SCHINDEWOLF GYM ADDITION  
KLEIN INDEPENDENT SCHOOL DISTRICT  
SPRING, TEXAS

39-25107-00  
JANUARY 17, 2025  
ADDENDUM 1

**ADDENDUM 001**

DLR Group Project No. 39-25107-00

39-25107-00  
MEP ROOF PLAN

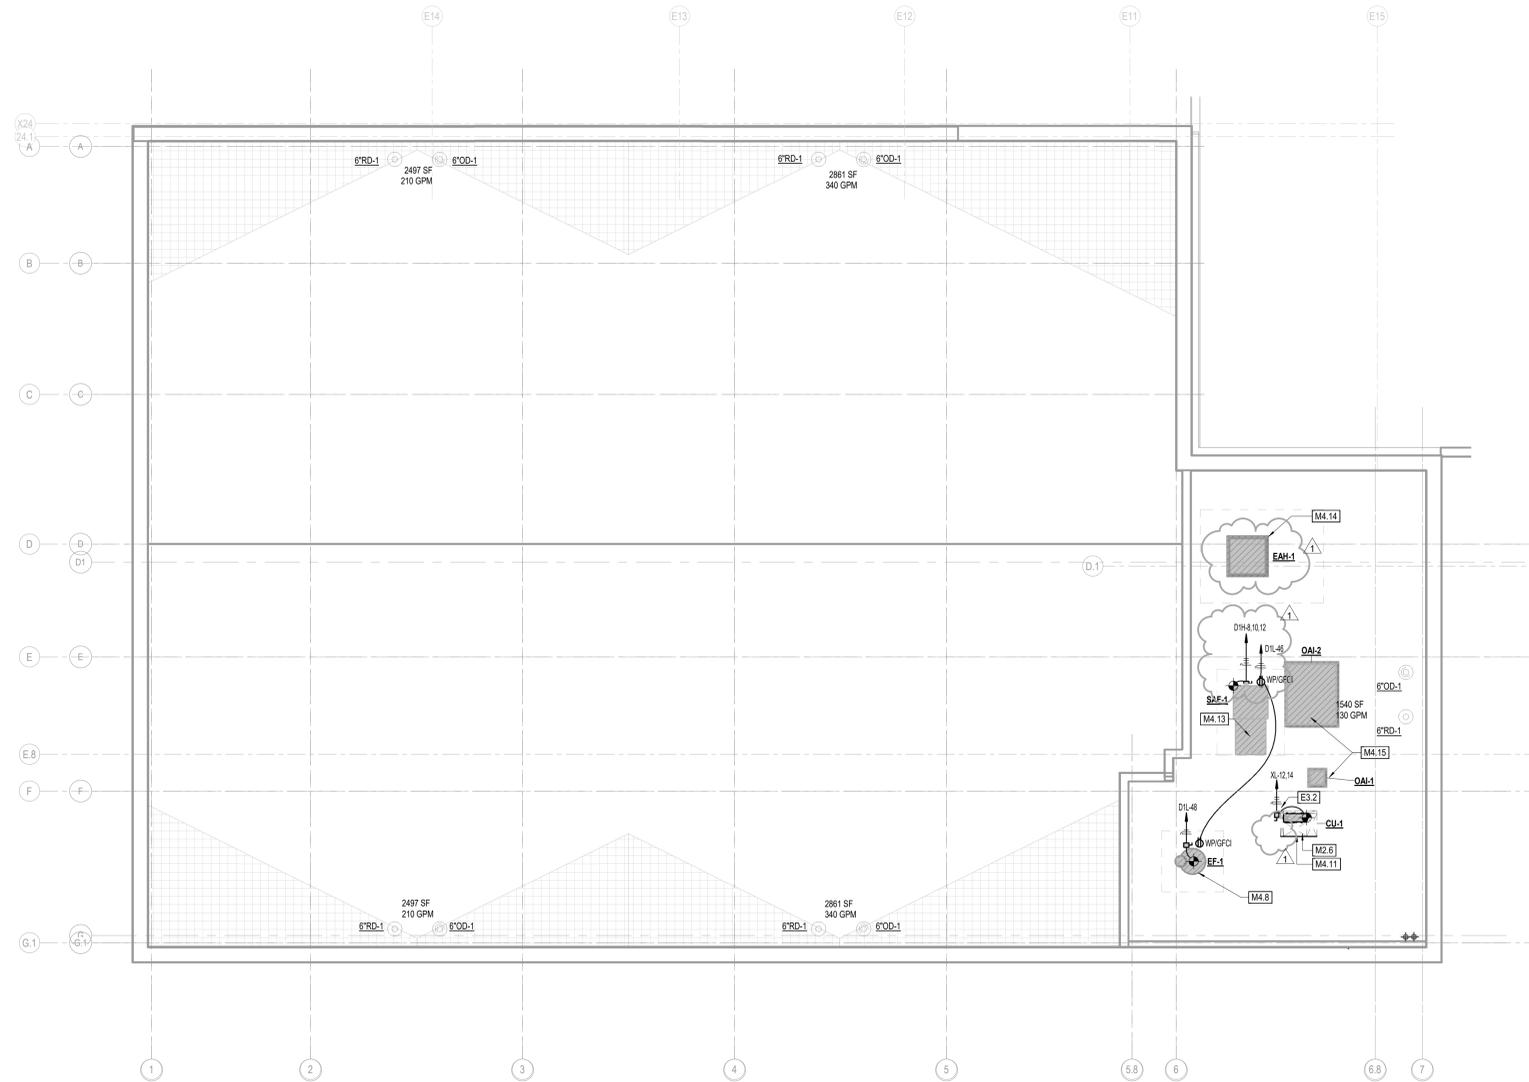
**ITEM NO. 11 - Sheet MEP.23 - MEP ROOF PLAN**

- a. Revised True North Arrow.
- b. Adjusted location of EAH-1.
- c. Removed (1) WP/GFCI. See revised sheet.
- d. Removed one electrical keyed note. See revised sheet.

**1 OVERALL PLUMBING PLAN LEVEL 1**  
1" = 20'-0"

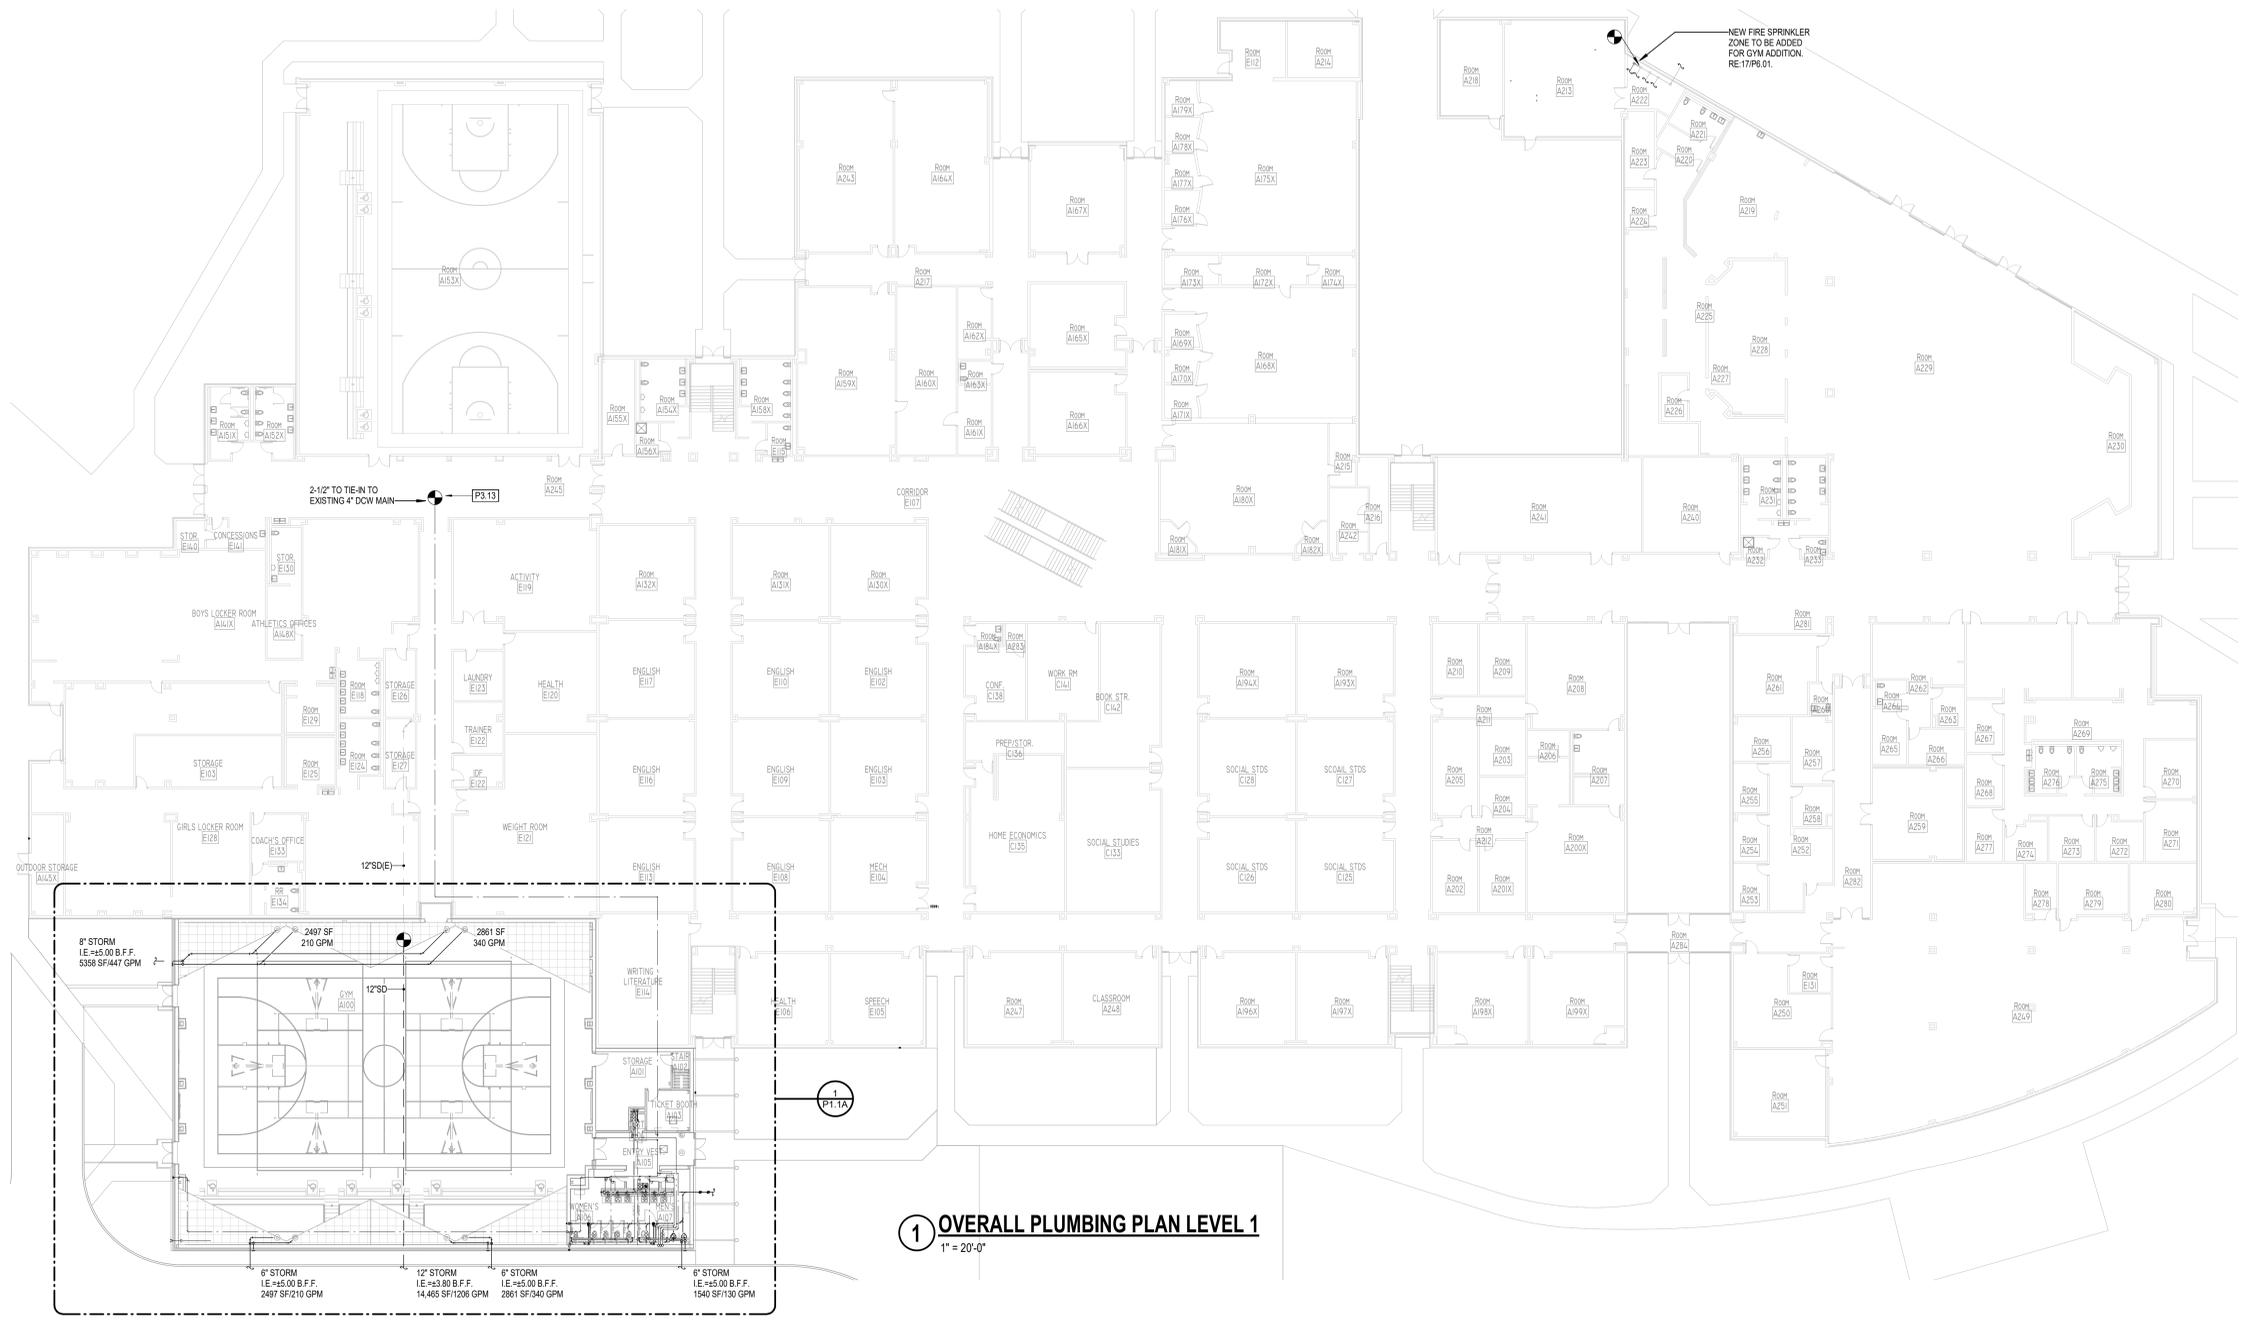
**ITEM NO. 19 - Sheet P1.1 - OVERALL PLUMBING PLAN LEVEL 1**

- a. Revised True North Arrow.

**1 PLUMBING PLAN LEVEL 2 - AREA A**  
1/8" = 1'-0"

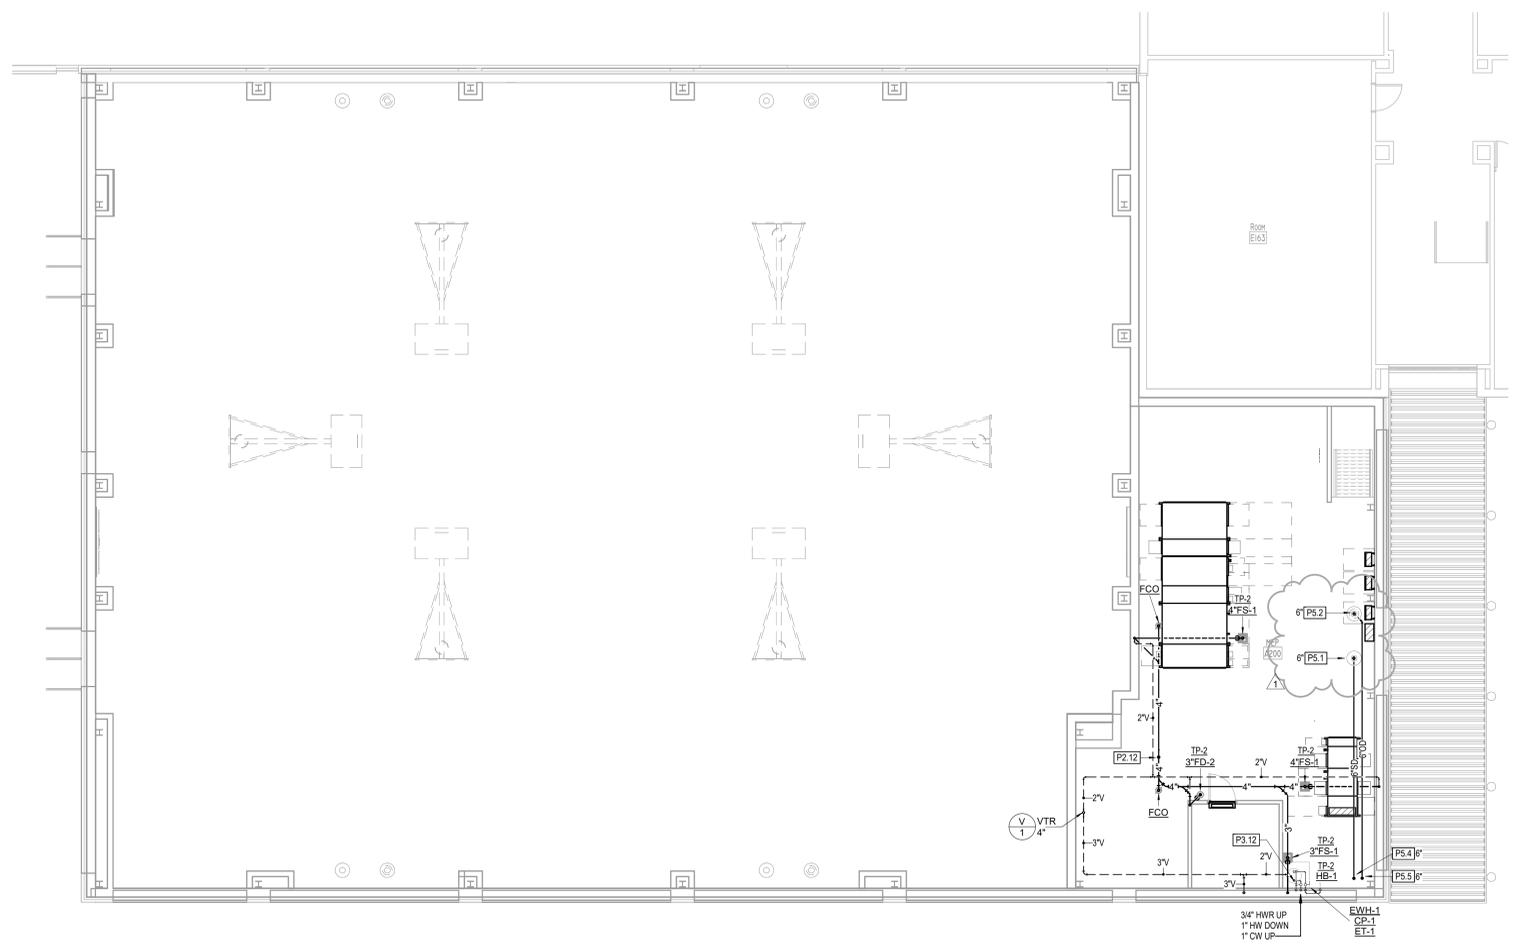
**ITEM NO. 22 - Sheet P1.2A - PLUMBING PLAN LEVEL 2 - AREA A**

- a. Revised storm and overflow storm line to match with roof drain location. See revised plan.
- b. Revised True North Arrow.

**1 OVERALL MECHANICAL PLAN LEVEL 1**  
1" = 20'-0"

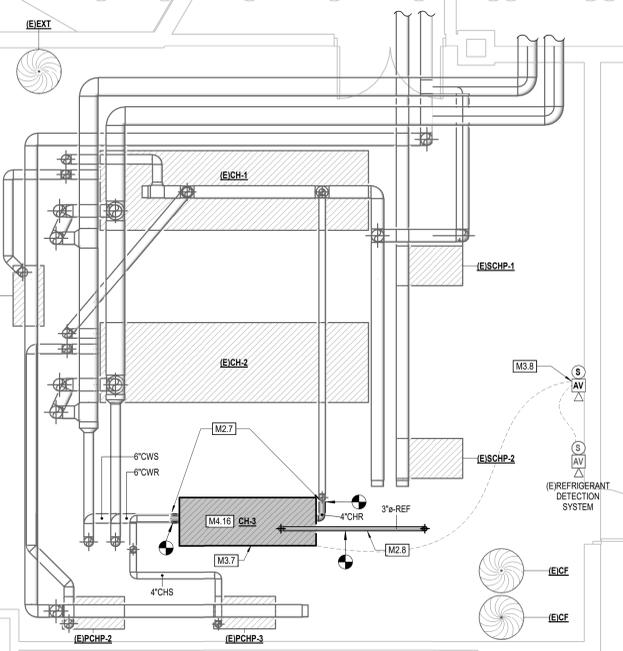
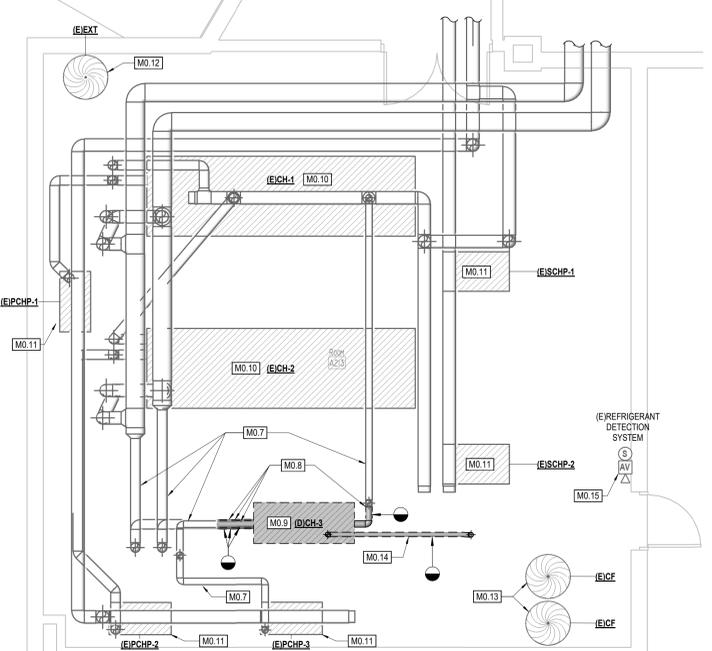
**ITEM NO. 12 - Sheet M1.1 - OVERALL MECHANICAL PLAN LEVEL 1**

- a. Revised True North Arrow.
- b. Tagged existing hydronic pipe sizes near MECH E104.

**1 ELECTRICAL LIGHTING PLAN LEVEL 1 - AREA A**  
1/8" = 1'-0"

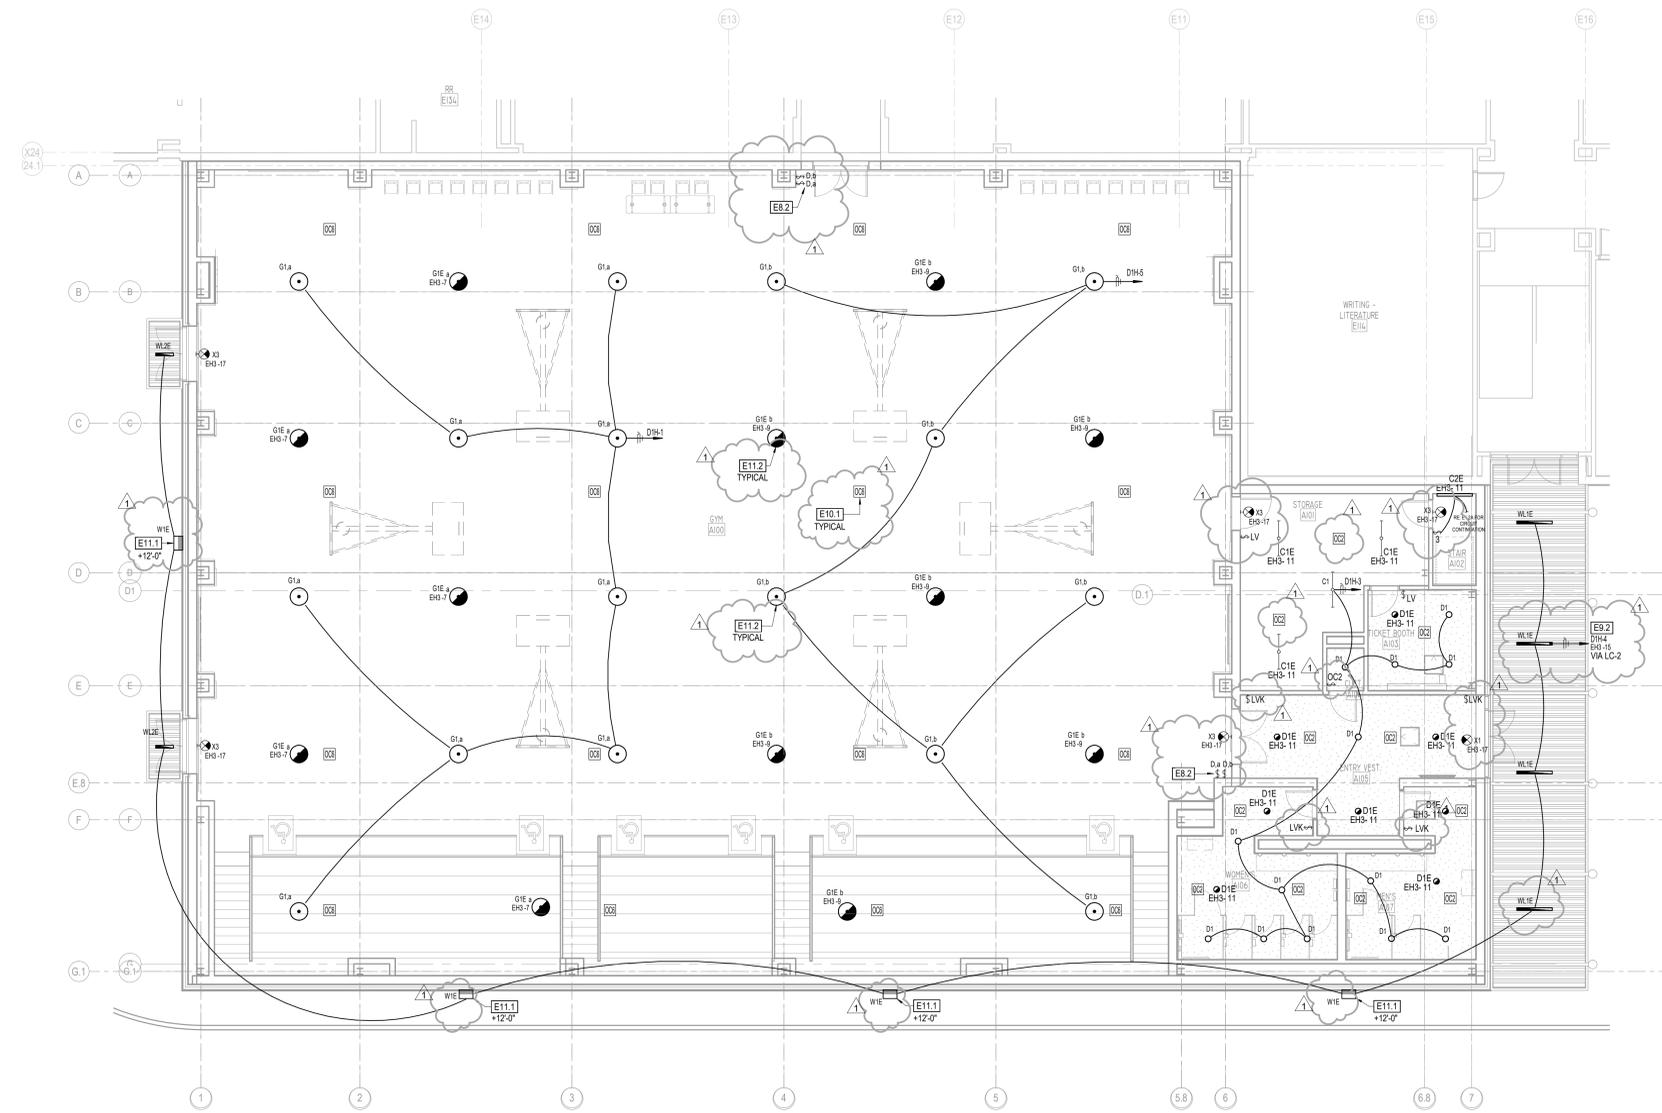
**ITEM NO. 29 -** Sheet E1.1A – ELECTRICAL LIGHTING PLAN LEVEL 1 – AREA A

- a. Revised true north arrows. See revised sheet.
- b. Added electrical keyed notes. See revised sheet.
- c. Revised lighting controls. See revised sheet.
- d. Added circuit to exit signs. See revised sheet.
- e. Relocated lighting controls. See revised sheet.
- f. Added lighting controls in gym. See revised sheet.
- g. All exterior lights changed to emergency type. See revised sheet.
